विषय :- मेसर्स सी0सी0एल0 की आम्रपाली कोयला खनन परियोजना हेतु कुल 431.59 हे0 वनभूमि अपयोजन प्रस्ताव के संबंध में।

S. No	Query raised by GoI on dt. 17.04.2023	Compliance of User Agency	Comments of DFO Chatra South
I.	The State Government shall provide present status of the offence report issued by the State Forest Department against erring officials for violation of Forest (Conservation) Act 1980 by the user agency.	<ul style="list-style-type: none"><li>• Final Stage-II approval has been granted Vide No: - FP/JH/ENCRH/150436/2021/827 dated 09.01.2023 for, road from Honhe to Shivpur Railway siding (Proposal No: - FP/JH/ENCRH/150436/2021 dated 22.12.2021).</li><li>• For regularisation of this road, five times Penal NPV and cost of Compensatory Afforestation for CA land ten times the area applied for regularisation has been paid in Jharkhand CAMPA.</li><li>• The forest proposal of 13.70 Ha Honhe Saradhu road applied vide no: - FP/JH/MIN/34877/2015 dated 21.07.2018 has been withdrawn.</li><li>• The part of old existing road connecting the villages Honhe to Saradhu was in existence even before the commencement of mining operation in the project which can be seen through comparative KML o

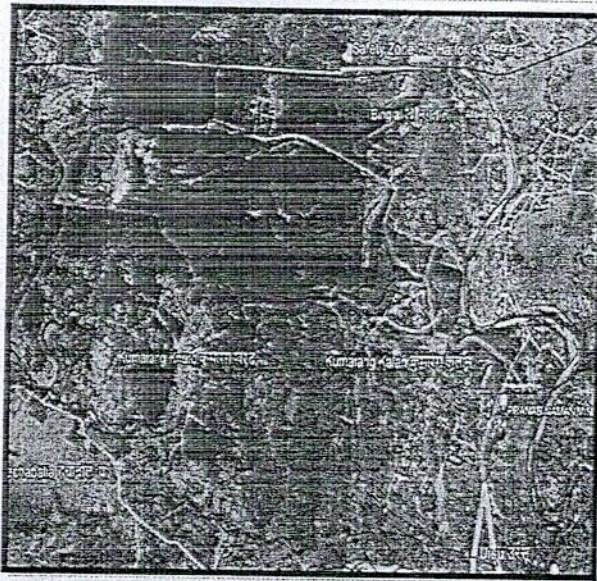
<b>Total</b>		<b>651.16 Ha</b>		
V.	<p>With regard to Safety zone maintained by the user agency, the State Government has informed that the proposed area covered under the instant proposal, not being maintained properly as in anticipation of acceptance of this</p>	<ul style="list-style-type: none"> <li>• The safety zone in respect of the forest proposal of 531.64 Ha Forest land for which Stage-II has been granted vide letter no.8-48/2008 FC dated 12.10.2010 is 4.5 Ha which was outside the diverted forest land as per the guidelines at that point of time.</li> <li>• Creation and protection of the safety zone has been done in compliance to the conditions stipulated for the purpose.</li> <li>• For continuation of mine and in order to start the next phase of mining operation, this safety zone area of 4.5 Ha is now proposed for diversion in the present application of 431.59 Ha.</li> </ul>			<p>The user agency has deliberated that 4.5 Ha of Forest land that was proposed as safety zone in respect of 531.64 Ha. For continuation of mine and in order to start the next phase of mining operation, this</p>

proposal. Maintenance of the safety zone is an essential condition. The justification for neither complying with it nor seeking its relaxation shall be submitted.

The details of safety zone maintained in lieu of diversion of 531.64 ha and activities viz plantation, ANR and afforestation over 1.5 times the area of safety zone shall be submitted.

- Further, it is to mention that 7.5 Ha safety zone is proposed for diversion in the forest proposal of 431.59 Ha (mentioned in component wise break up in FORM A) which will not be disturbed and maintained as per guidelines.

The 7.5 Ha safety zone proposed in current proposal is shown above in the screenshot of KML.
